RESPONSES TO  
NRC QUESTION  
ON THE  
DUANE ARNOLD ENERGY CENTER  
PUAR

PREPARED BY  
NUTECH ENGINEERS, INC.  
SAN JOSE, CALIFORNIA

PREPARED FOR  
IOWA ELECTRIC LIGHT AND POWER CO.

NRC QUESTION ON DUANE ARNOLD ENERGY CENTER

Figure 11 - 4"φ

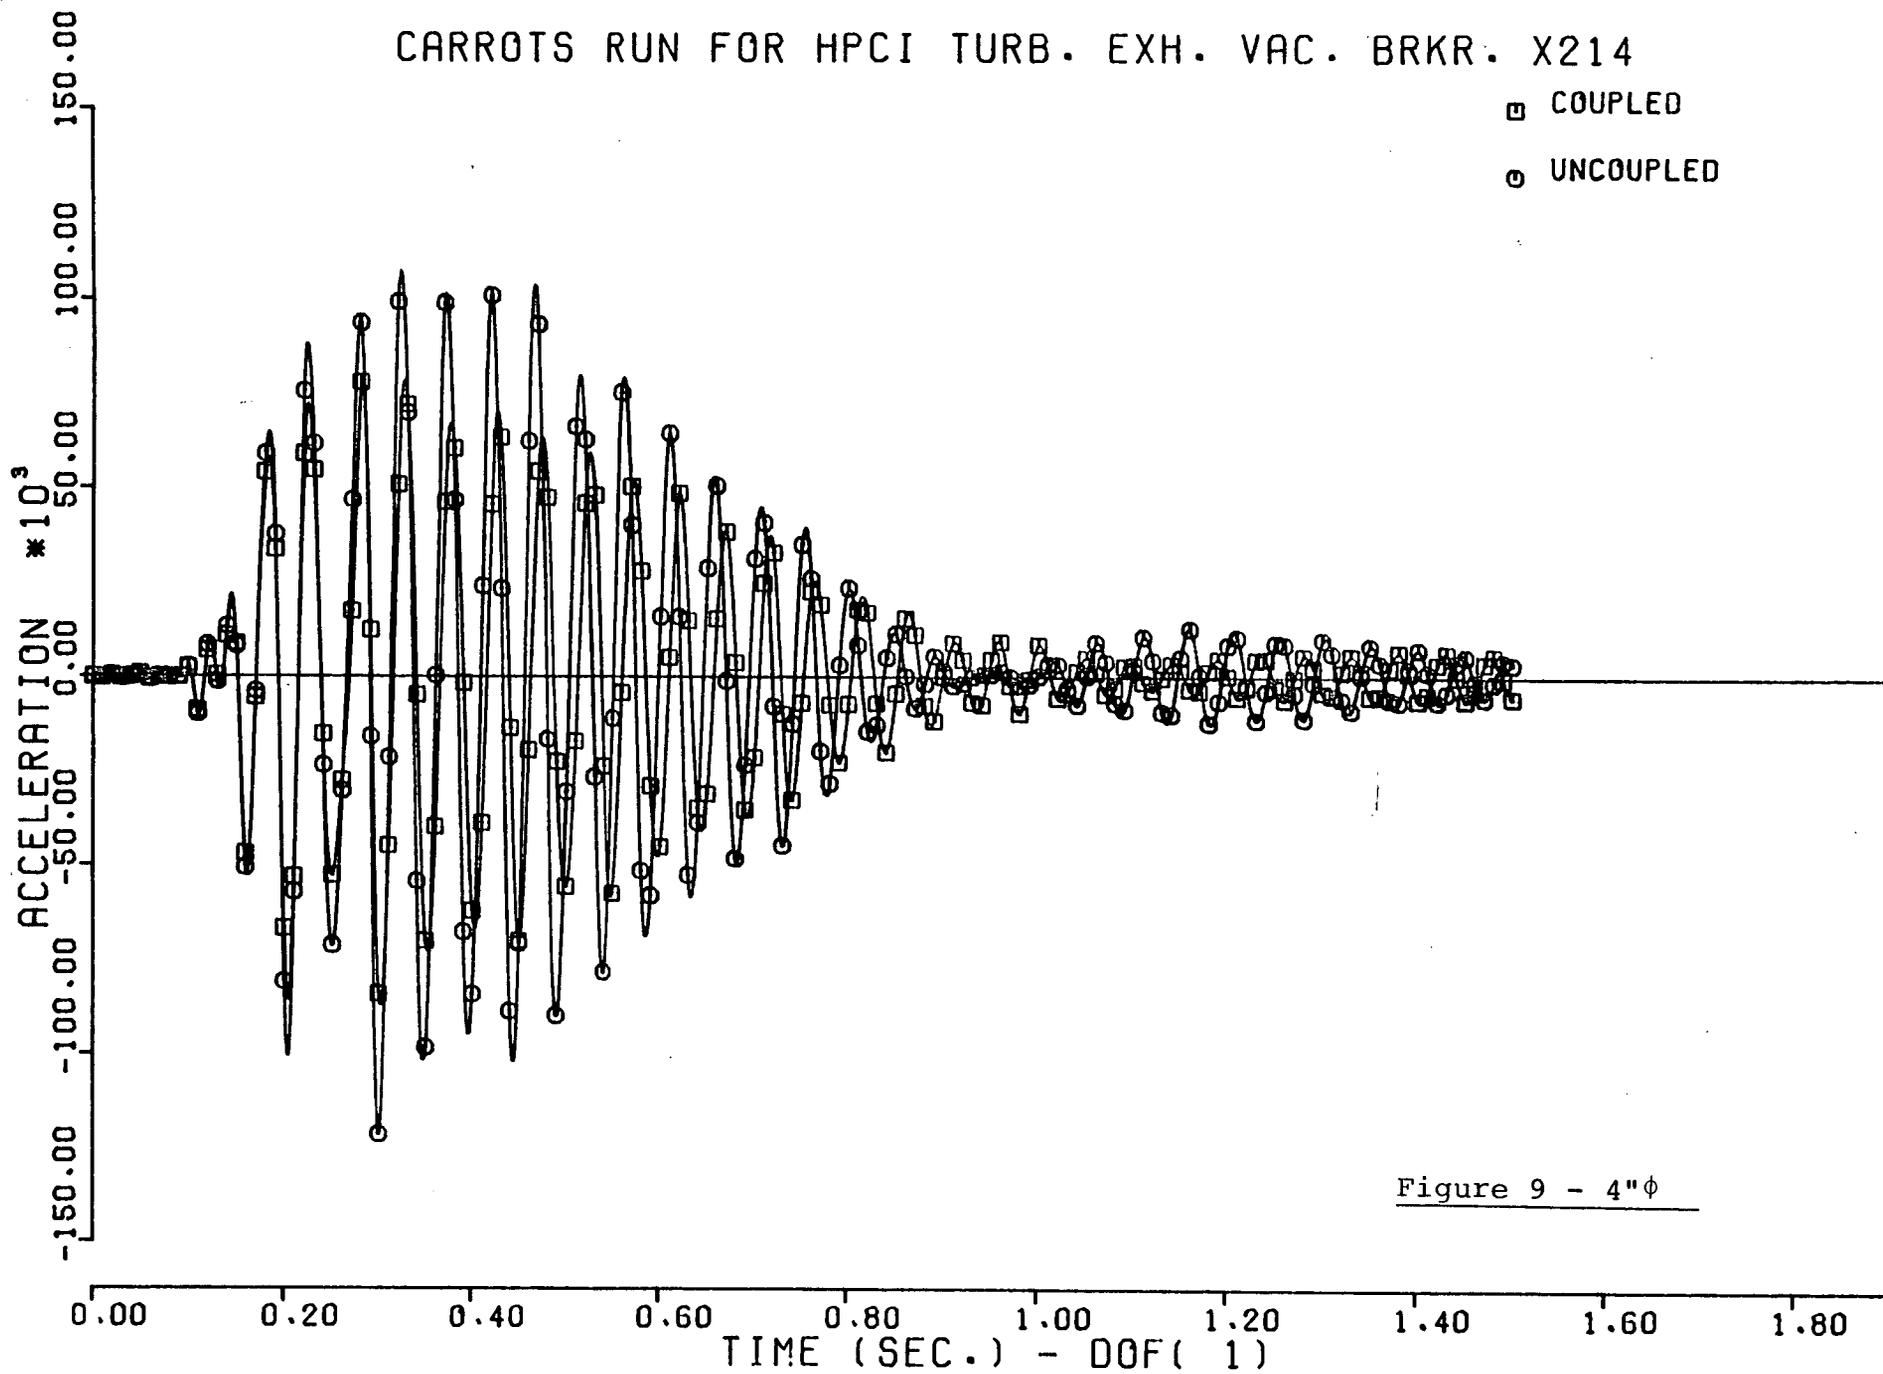
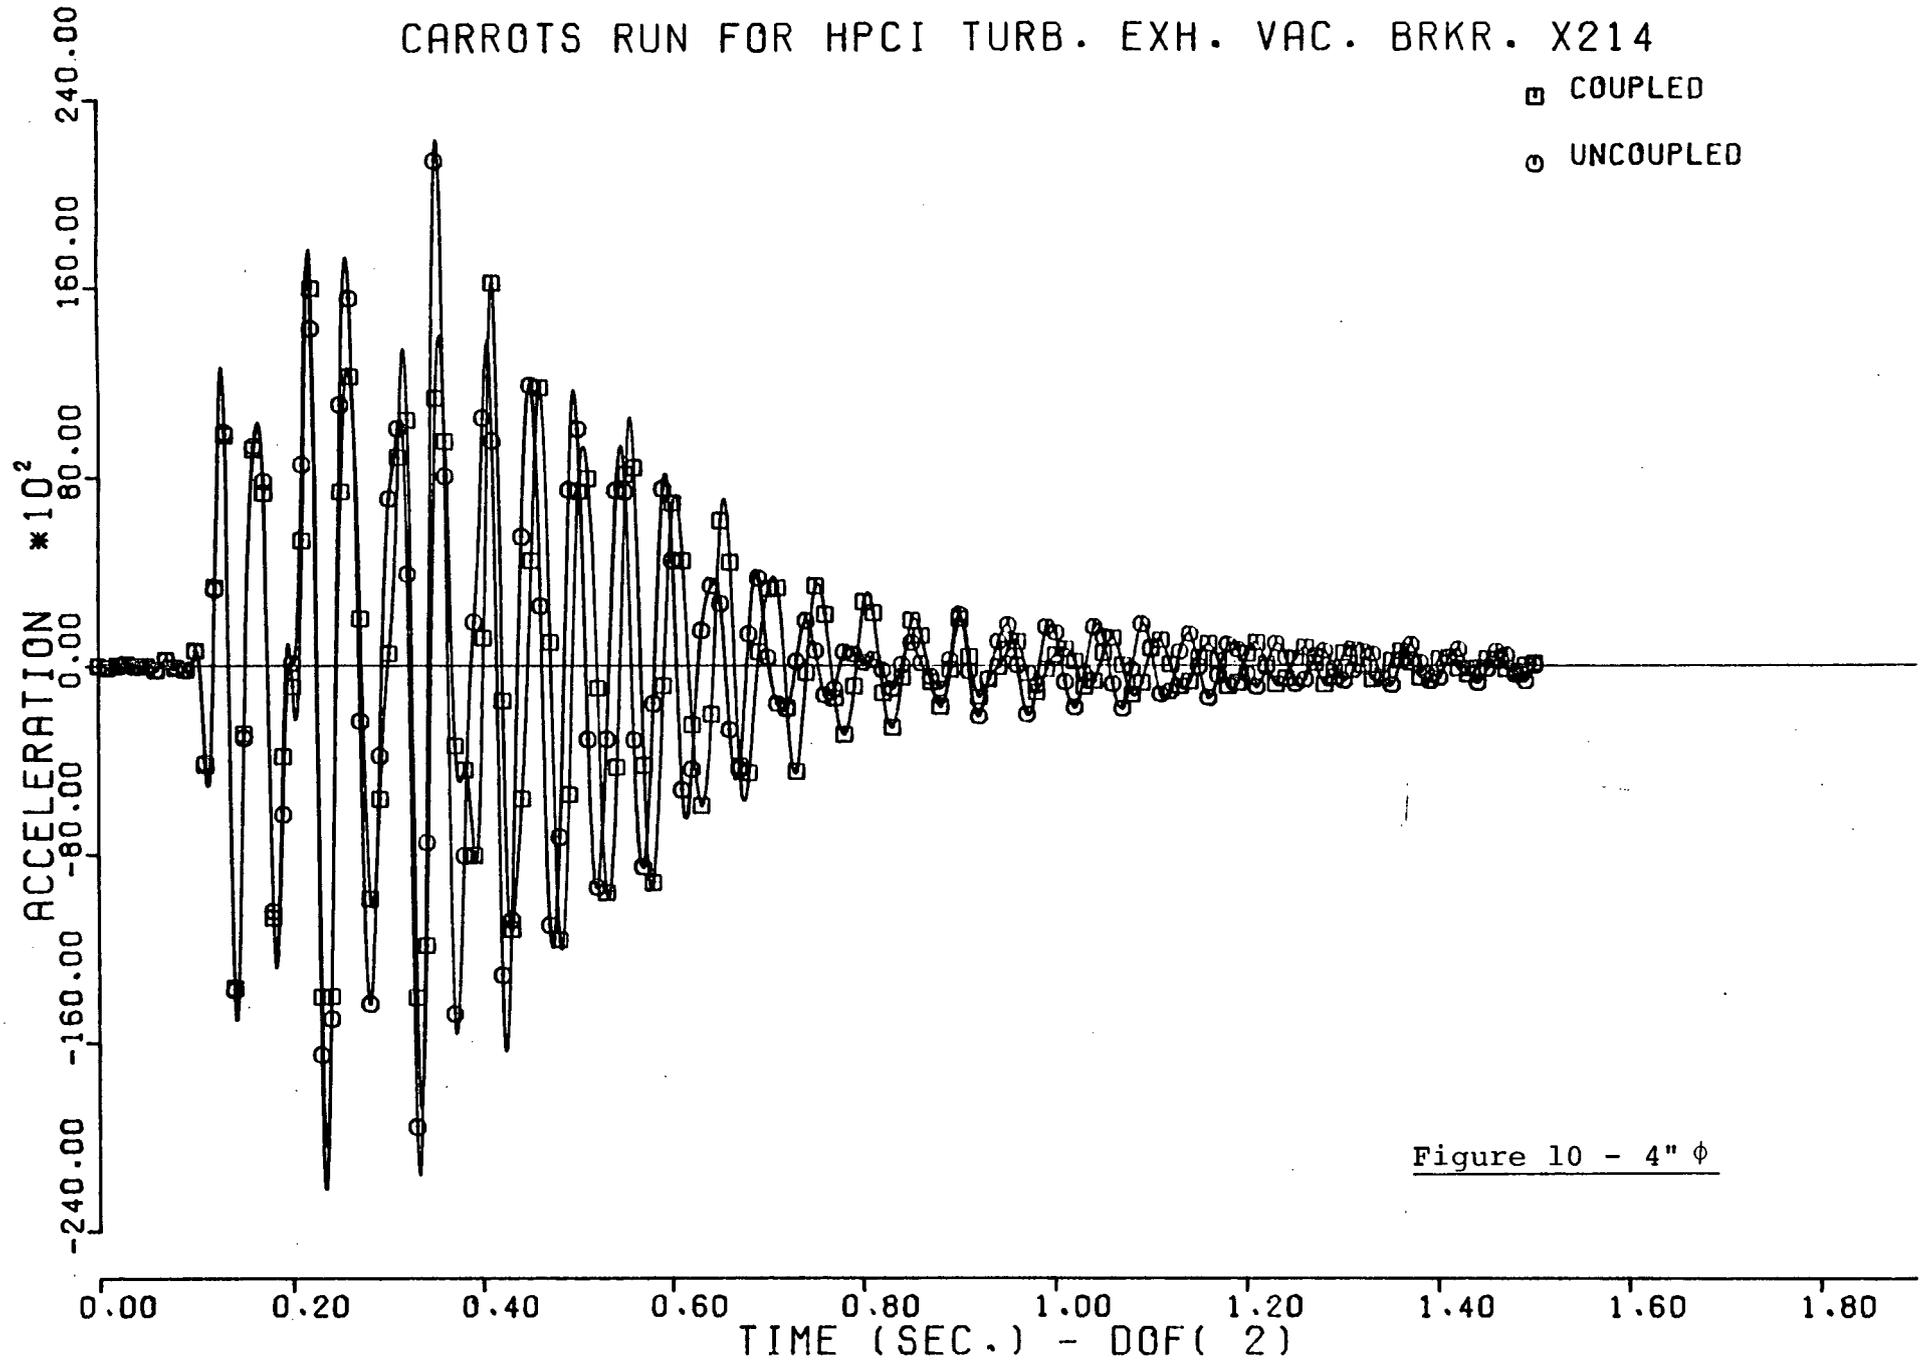
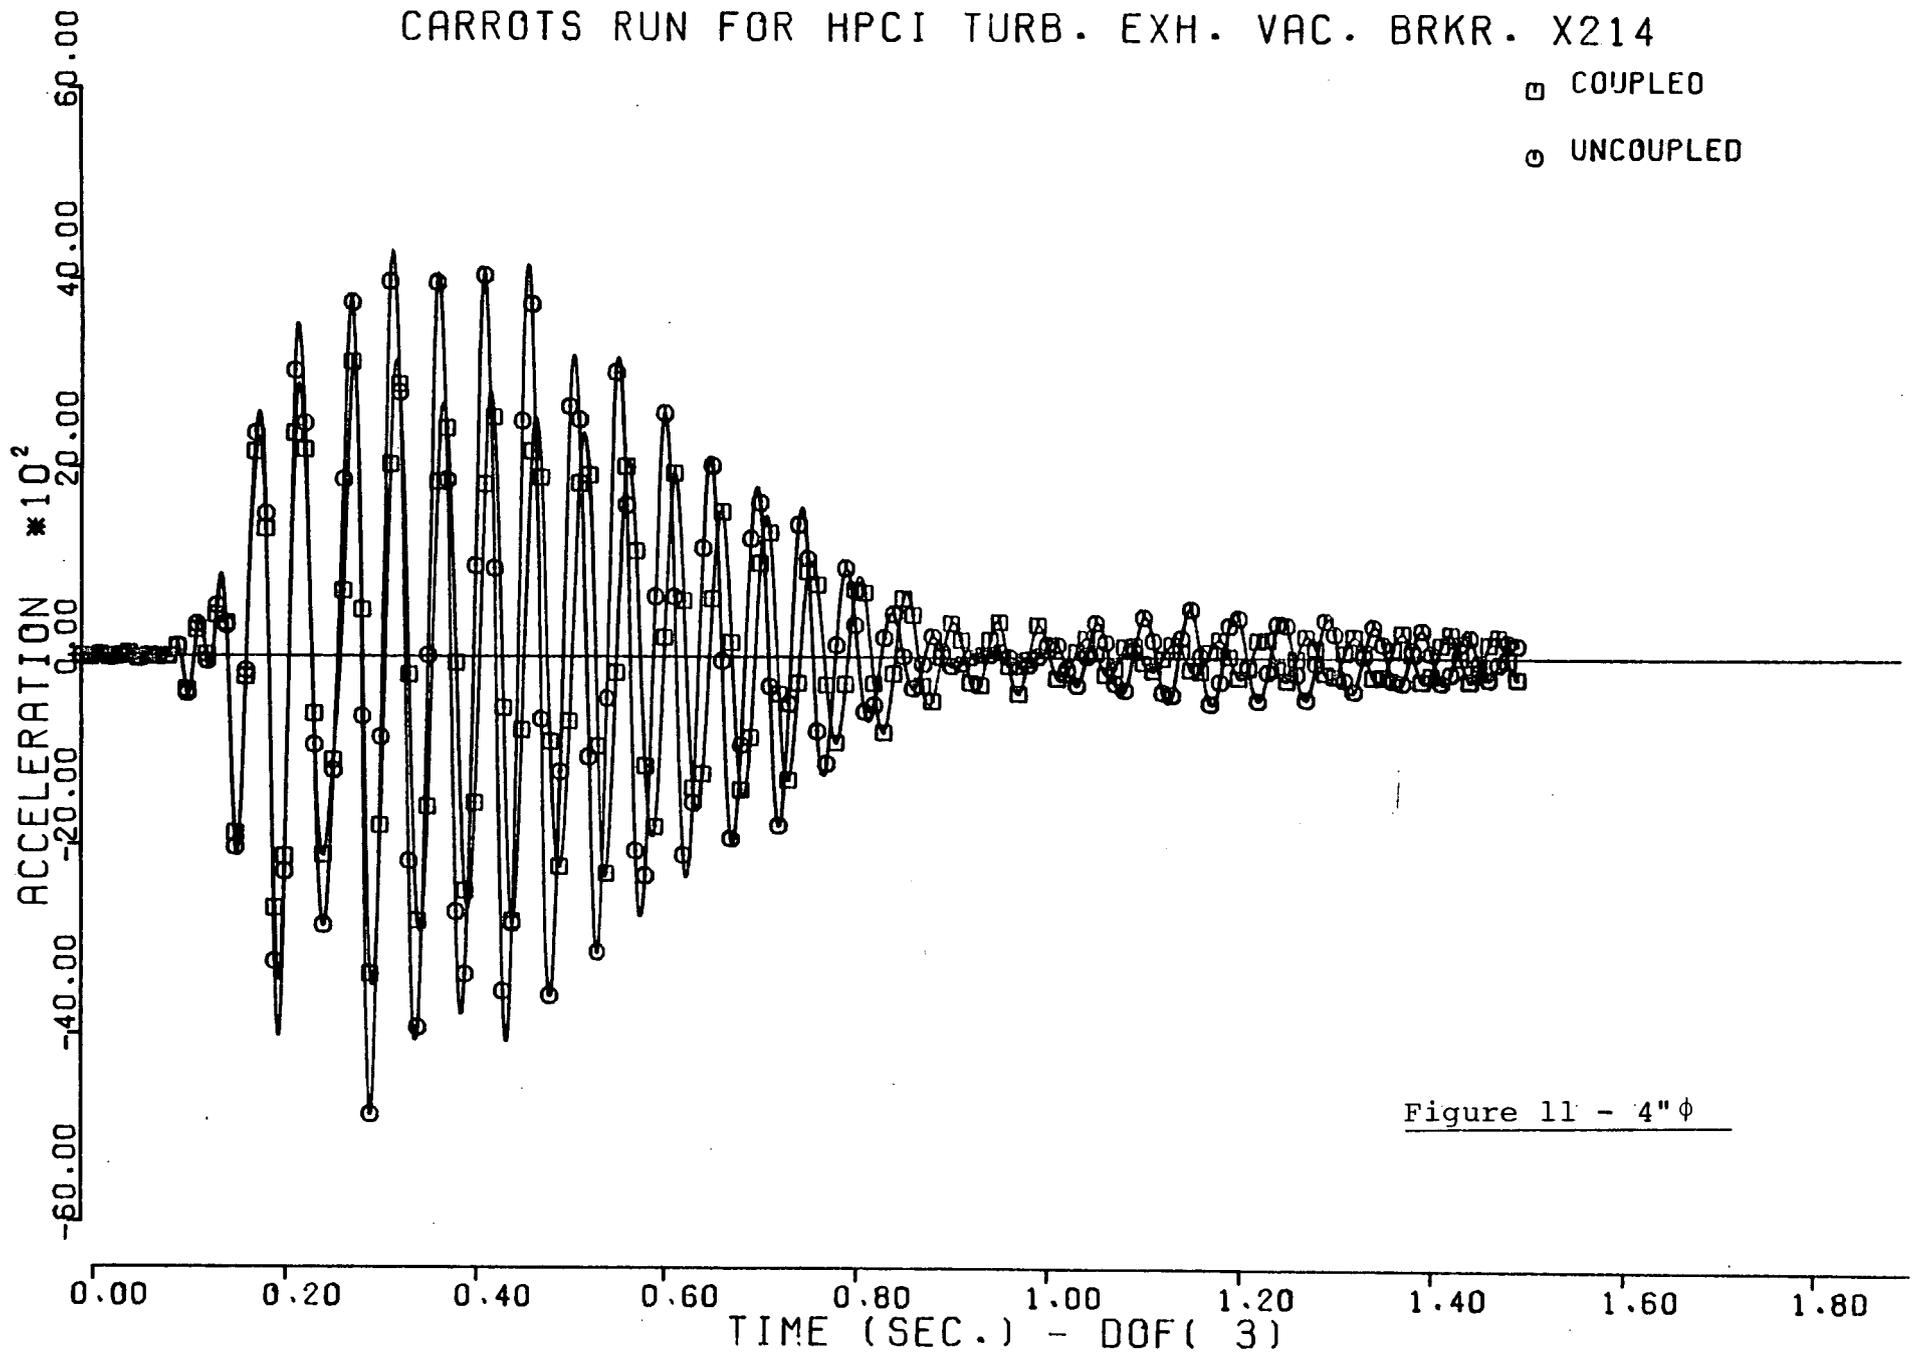
ITEM 3a: Provide the theoretical background in support of Section 2 of the report, and describe how the Section 6 guidelines (i.e., cut-off frequency and equations 2.27 and 2.28) have been used in the analysis.

To illustrate the effect of pipe size on coupling, four typical piping systems were examined and the coupled and uncoupled time histories plotted together. These time histories include both the smallest (2") and larger (20") systems analyzed. Listed below are the figure numbers and the corresponding line size.

Figure 4-8	2" diameter
9-13	4" diameter
14-18	6" diameter
19-21	20" diameter

These plots confirm the expected variation of coupling benefit with pipe size.
